**SLR special meeting on
“Headlamp levelling”
18 May 2022,**

Response for SLR-HL-24

Polish proposal (GRE-85-19)

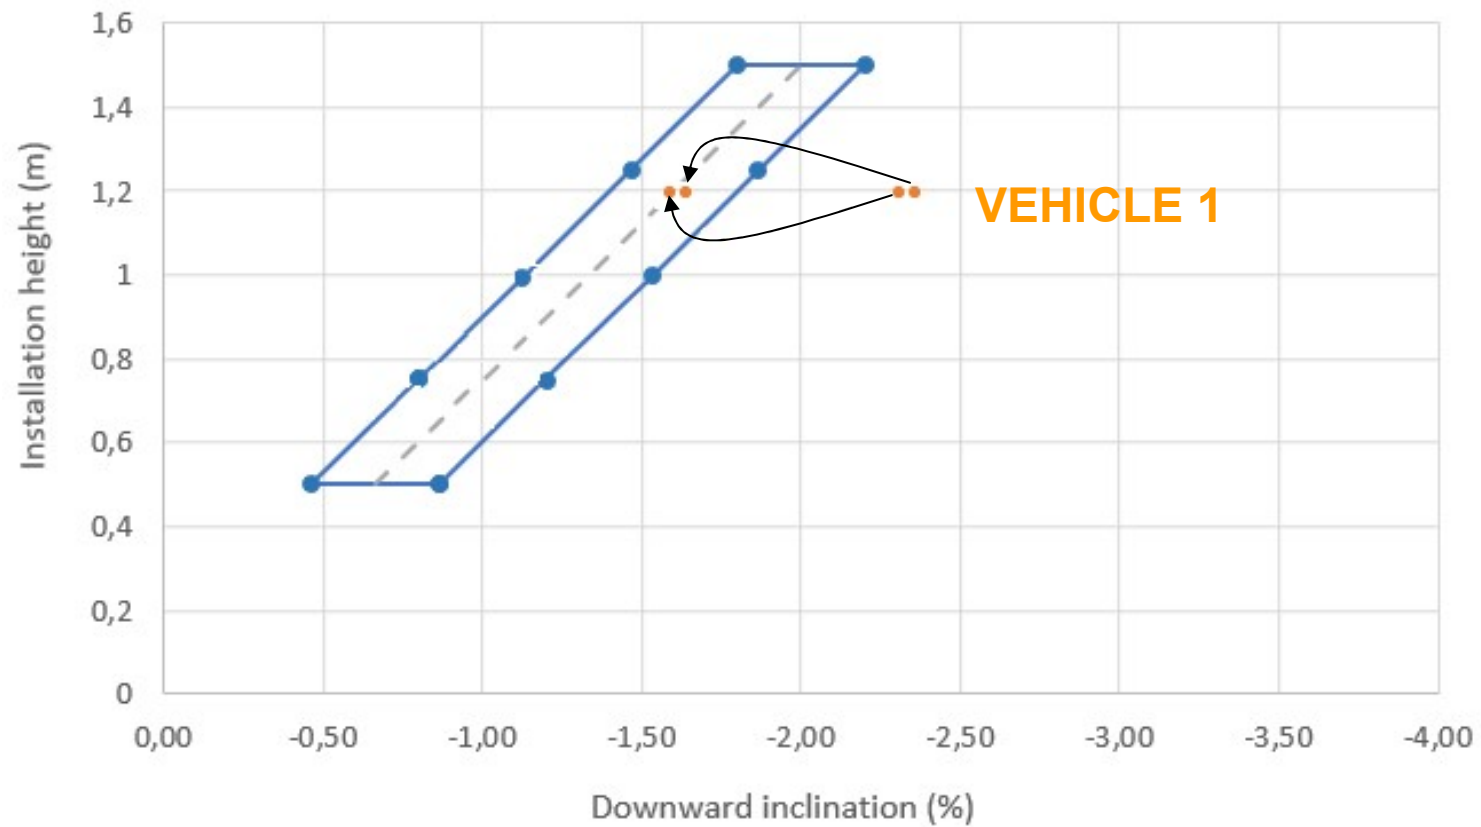
To verify feasibility the data should be presented as above.

In fact it is sufficient to show the difference between minimum and maximum measured values

Polish proposal (GRE-85-19)

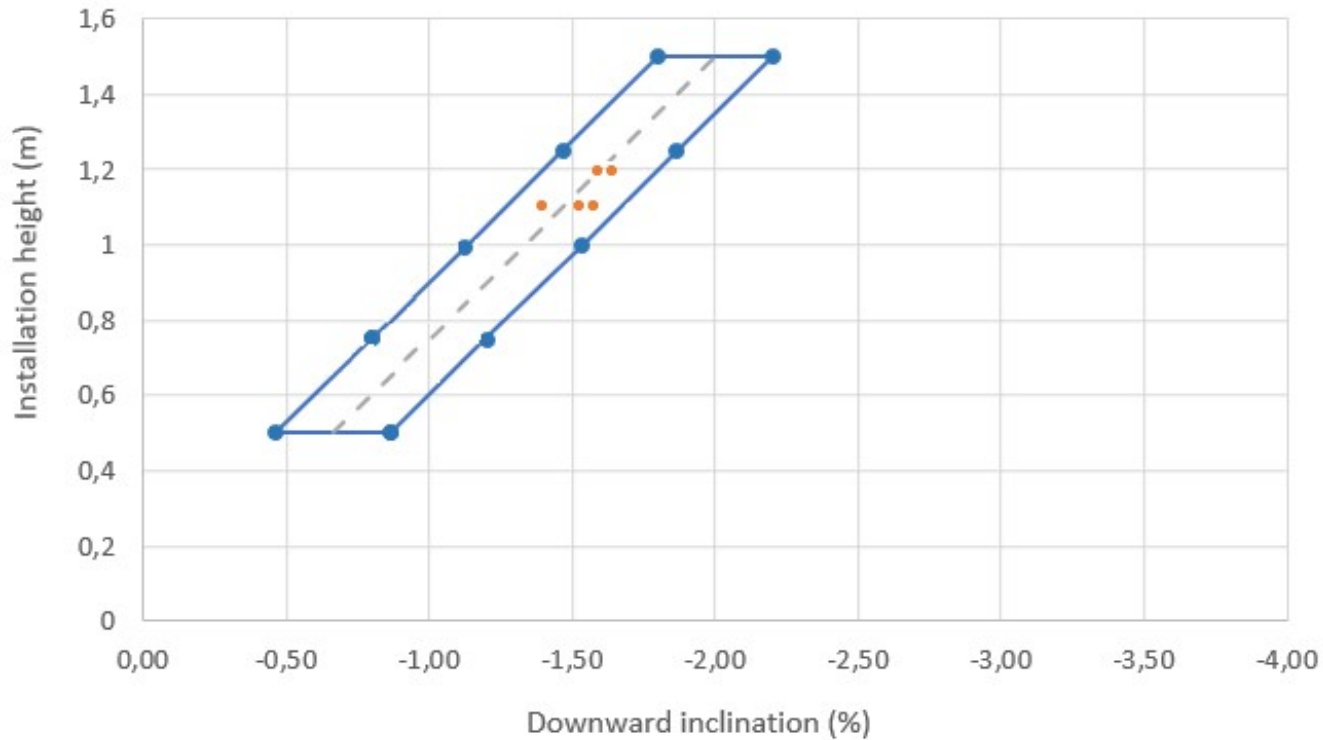
Above two examples presented by OICA confirm the feasibility of Polish proposal. The rest of the results looks strange as the consequence of the automatic levelling operation – details and independent verification are needed
